Project: Great Wolf Lodge, Chesterton  
Prepared by: Kathryn Lewis/ David Lewis  
Approved by: Phil Bell  
Date: 04/09/2020

**GREAT WOLF RESORT, BICESTER - STAGE 1 RSA IN RESPECT OF JUNCTION IMPROVEMENT AT MIDDLETON STONEY**

Proposed Junction Improvement at Middleton Stoney

Drawing: **1803047-TK62** Revision: -

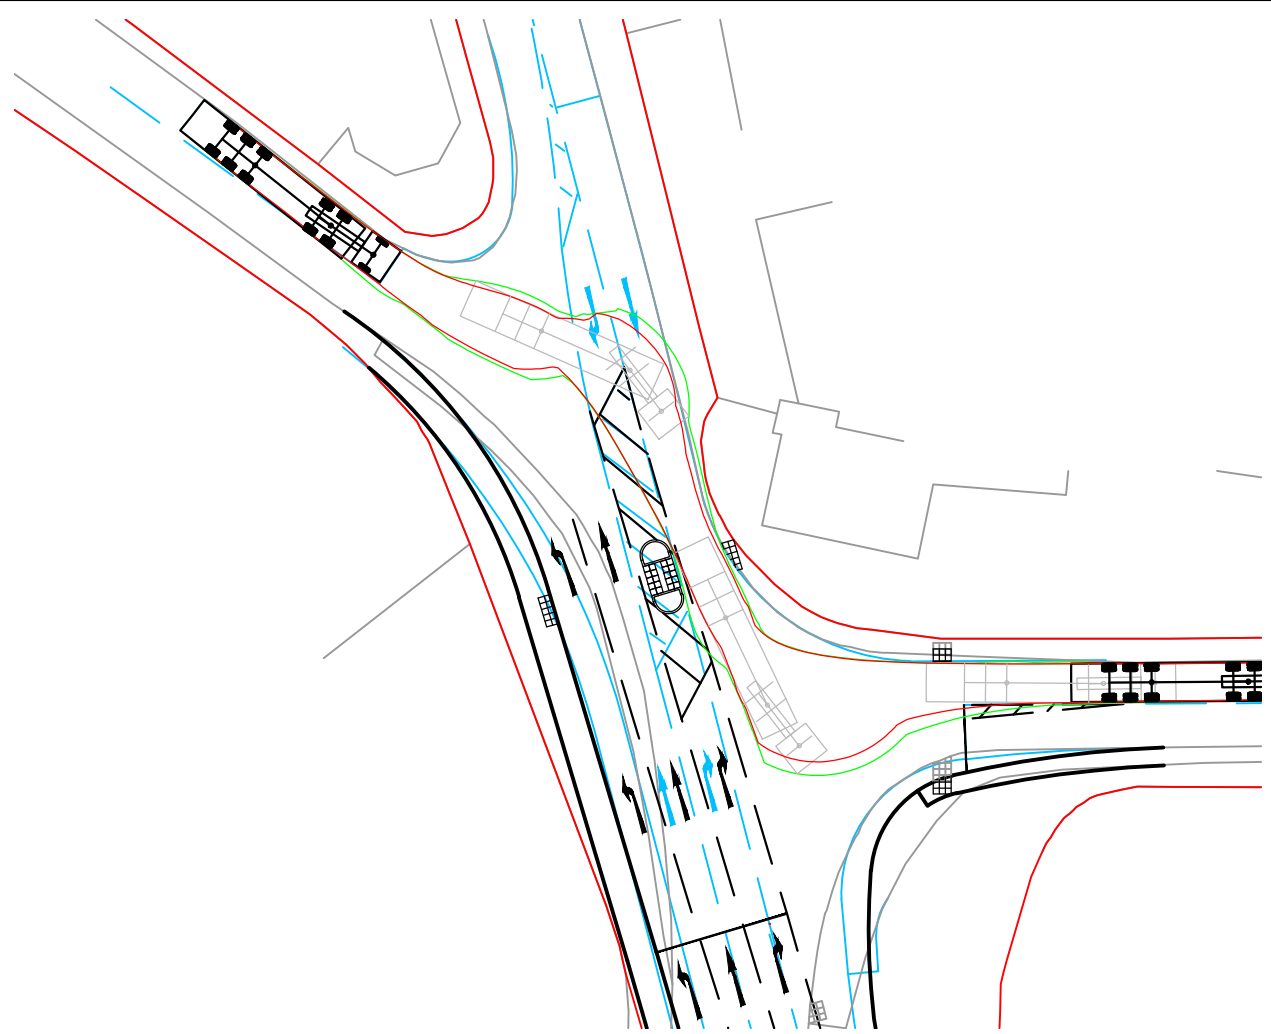
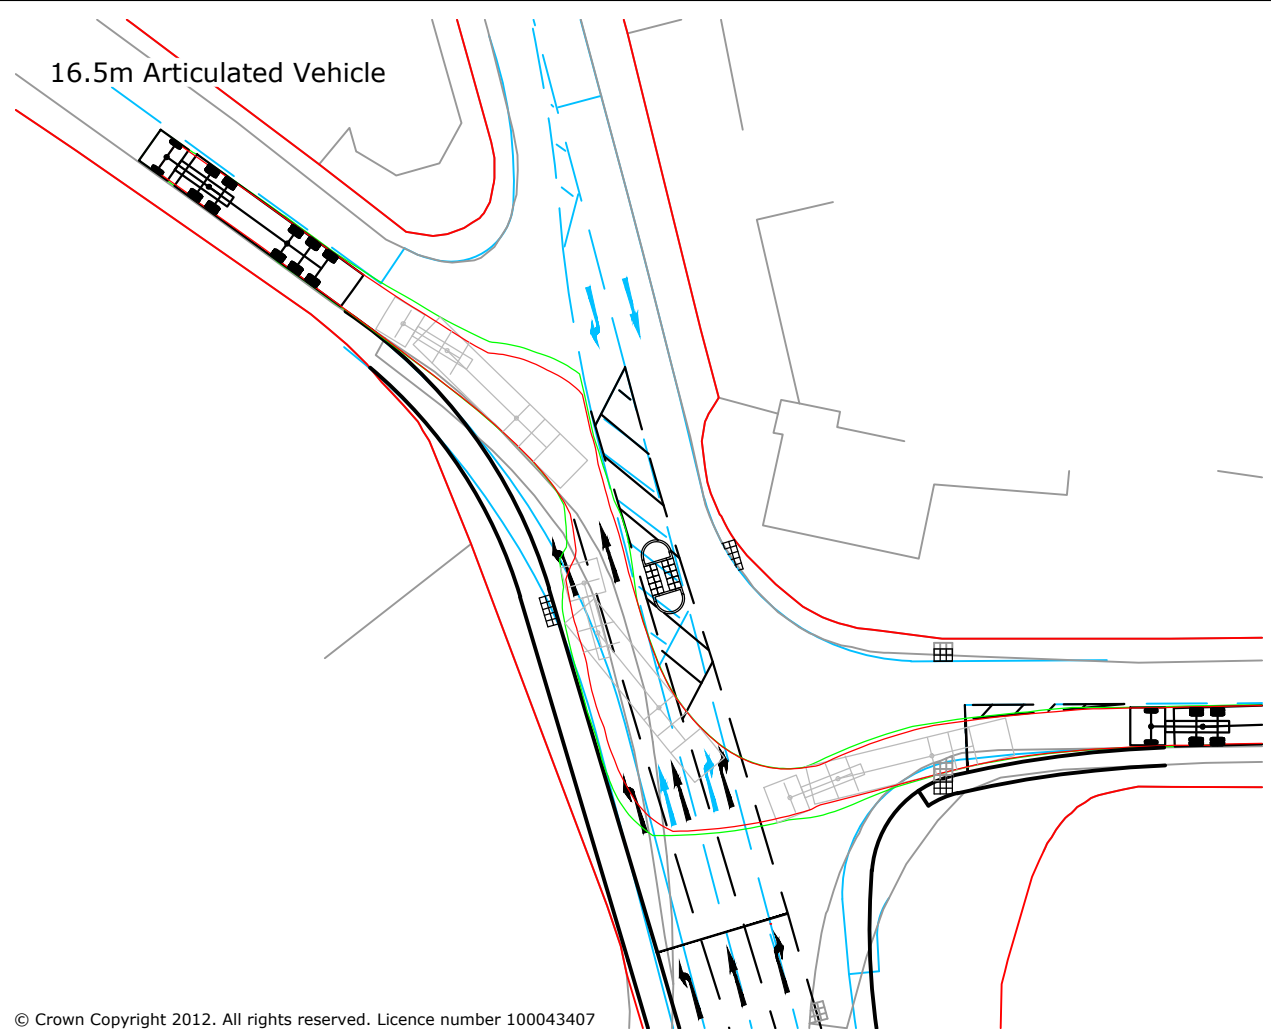
- ▶ As requested by OCC, swept path analysis has been undertaken for HGVs and articulated vehicles routing from the B430 east to west and *vice versa* and this is shown at Drawing 1803047-TK62, attached at [Appendix B](#). The swept path analysis demonstrates that a 10 metre rigid vehicle and 16.5 metre articulated vehicle can manoeuvre appropriately from the B430 east to the B430 west and *vice versa* and will not conflict with the proposed pedestrian refuge; and,
